TSB0806: Hub for Cobra Friction Drive (CFD or 'Slipper') replacement for 2006 King & CM

January 23, 2006

Early 2006 King & CM units had CFD (slipper) hubs of improper material that allowed them to wear quickly. Owners of these models have been contacted and sent a free replacement hub. Below are instructions for replacing the hub.

Figure 6. New CFD hub, (Old style has visible thru holes)

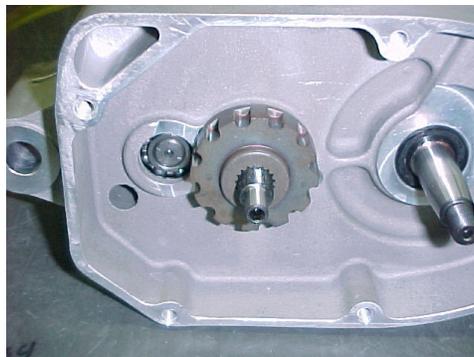
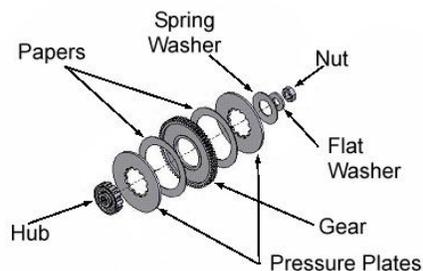
8. Remove the CFD hub and slide on the new one (old style has holes, new style does not). Figure 6

9. Reinstall inner pressure plate (both are physically the same), paper, gear, paper, outer pressure plate, CFD spring washer, and then the flat washer.

10. Install the blue CFD nut (remembering that it is left hand thread) and torque to 75 Nm (55 ft-lb).
11. Reinstall the clutch basket shims, basket & clutch per owners' manual.
12. Reinstall the clutch hub nut and torque to 47 Nm (35ft-lb).
13. Reinstall clutch cover and fill with 8 oz Cobra Clutch Milk.
